Service Bulletin

Subject: Malfunction Indicator Lamp (MIL) Illuminated, DTC P0442 and/or P0455 Set

Models: 2012-2013 Chevrolet Express 3500-4500 Cutaway Vans
2012-2013 GMC Savana 3500-4500 Cutaway Vans
Equipped with Upfitter Body and Side Mounted Fuel Tank

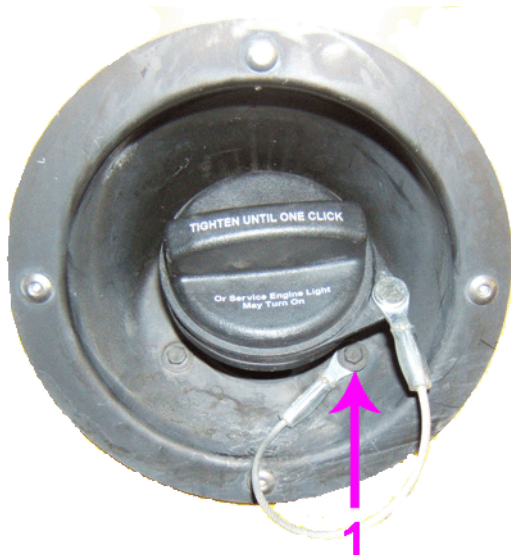
This condition may be caused by the fuel cap tether binding when installing the fuel cap and not allowing the fuel cap to seal completely or by the fuel cap tether being trapped between the fuel cap seal and the fuel fill pipe, not allowing the fuel cap to seal completely.

The fuel cap tether will need to be repositioned from its current attachment point within the fuel fill pipe housing to the external 3 o'clock position or the fuel fill pipe housing edge.

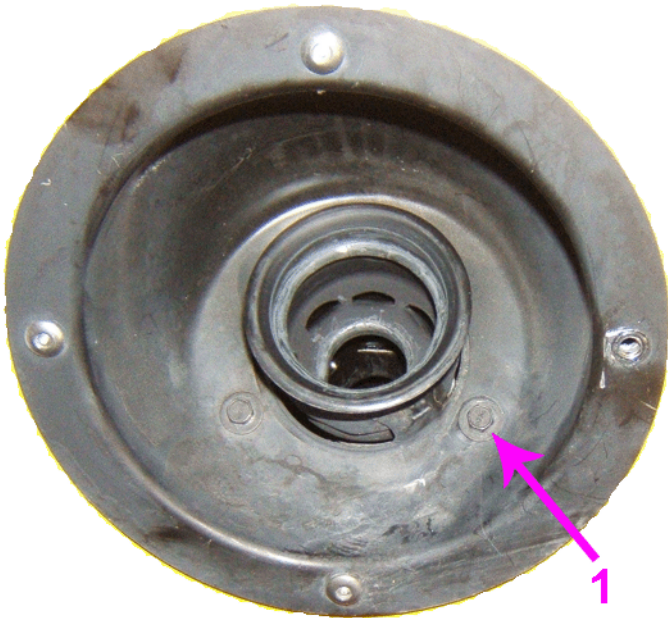
4. Remove the fuel cap tether fastener (1) from its attachment point within the fuel fill pipe housing.

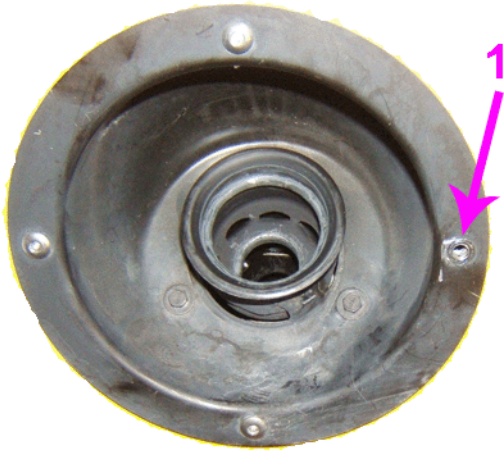
5. Reinstall the fastener (1) to its original attachment point within the fuel fill pipe housing.

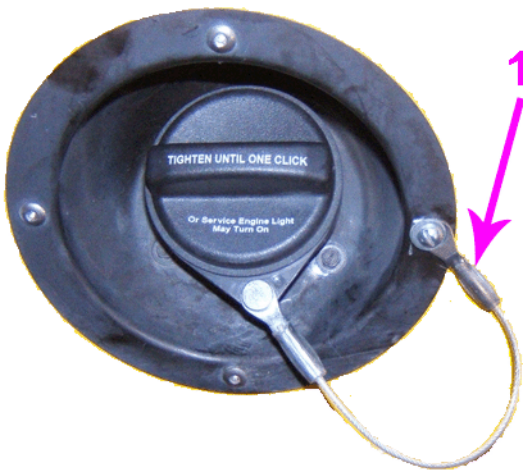
6. Remove the fastener at the external 3 o'clock position on the fuel fill pipe housing edge.

7. Install the gas cap.
 - 7.1. Orient the fuel fill cap tether, with the crimp side (not shown) of the tether terminal (1) **towards** the vehicle box as shown.
 - 7.2. Install a new fastener through the fuel fill cap tether terminal into the external 3 o'clock position attachment point on the fuel fill pipe housing edge and secure it.
